Project Memorandum

To:	KGHM Ajax Mining Inc.	Doc. No.:	BGC-026
Attention:	Nettie Ore	cc:	
From:	C. Koenig	Date:	January 23, 2017
Subject:	Ajax Project EA/EIS - Responses to Round 2 Information Requests from ECCC		
Project No.:	1125011

2.1. Comment #ECCC-098.1

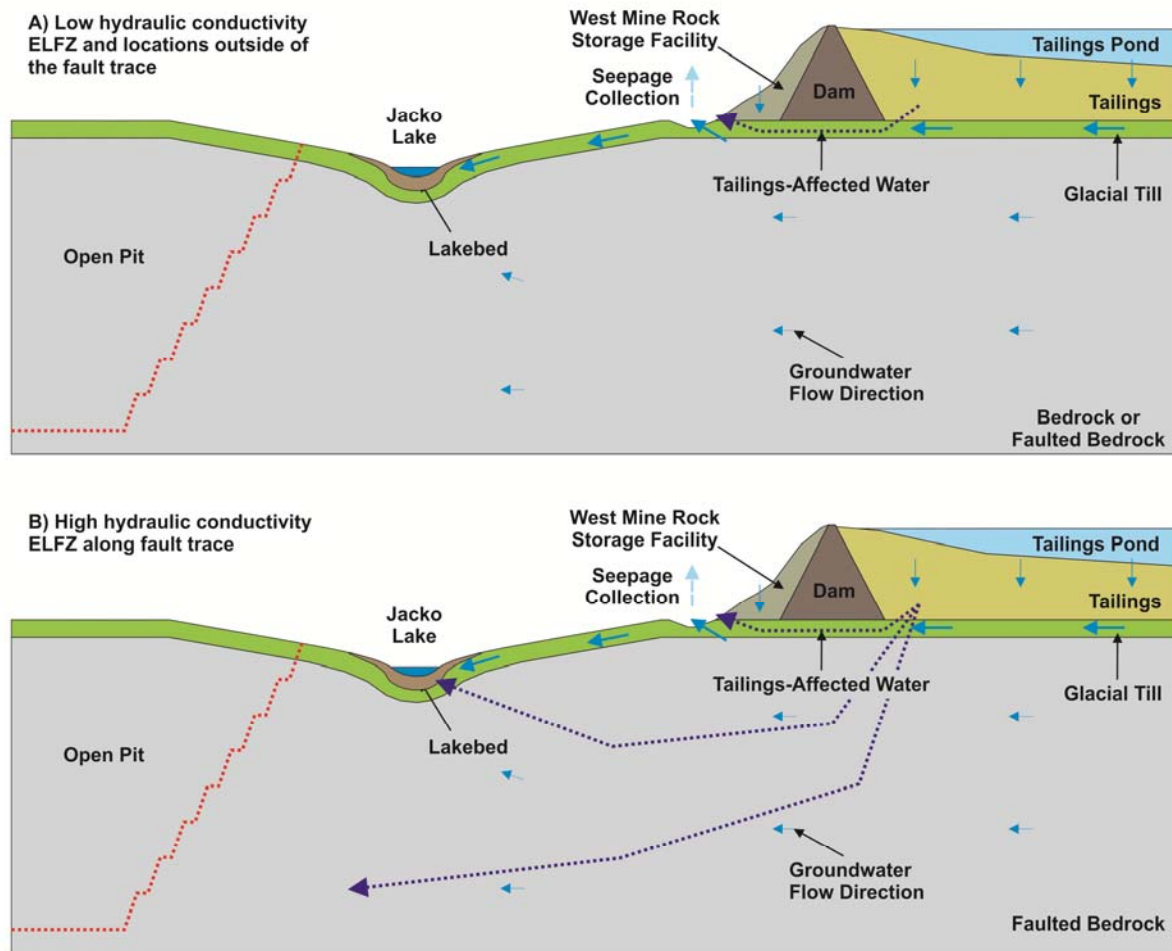
- Cross-sections, similar to Figure 2 from memo 0706_KAM_ELFZ_Model_BGC-002, showing particle paths for each of the scenarios depicted in Figures 8 to 11 from the memo;*
- Conservative estimates of the proportion of particles entering Jacko Lake (top of the lake bed) versus all particles leaving the mining facility; and*
- As assessment of the impacts of the ELFZ on Jacko Lake water quality by using these proportions as proxies, as well as the travel time through the lake bed, to conservatively estimate the impact on water quality (including a discussion on the limitations of the approach and possible need for a more complex transport model and/or investigation.)*

Conceptual cross-sections similar to Figure 2 of 0706_KAM_ELFZ_Model_BGC-002 showing particle paths are provided in Figure 1 (Figure 2 of 0706_KAM_ELFZ_Model_BGC-002 is reproduced as Figure 2 below for reference). The cross-sections provided are limited to the tailings storage facility (TSF) and west mine rock storage facility (WMRSF), where particle tracking analyses indicated the potential for seepage to flow towards Jacko Lake (see 0706_KAM_ELFZ_Model_BGC-002 Figures 8 and 9). Figure 1A depicts predicted groundwater flow paths for locations outside of the fault zone and for Edith Lake Fault Zone (ELFZ) hydraulic conductivity scenarios (i.e., $<5 \times 10^{-7}$ m/s). For these scenarios, groundwater simulated to originate from the footprints of the TSF and WMRSF was generally predicted to discharge near the toe of the dam/WMRSF (where it would evaporate or drain to the water collection ponds) or remain in the subsurface and flow towards the proposed open pit, with no discharge from the facilities predicted to reach Jacko Lake within the simulated 200-year timeframe.

Figure 1B depicts predicted groundwater flow paths for ELFZ simulated with hydraulic conductivity $>5 \times 10^{-7}$ m/s along the trace of the fault. For these scenarios, groundwater flowing along the fault trace that originated from the footprints of the TSF and WMRSF was predicted to follow three potential flow paths, including:

- A shallow groundwater flow path with discharge near the toe of the dam/WMRSF,
- An intermediate groundwater flow path with eventual discharge to Jacko Lake, and
- A deeper groundwater flow path that flows beneath and beyond Jacko Lake.
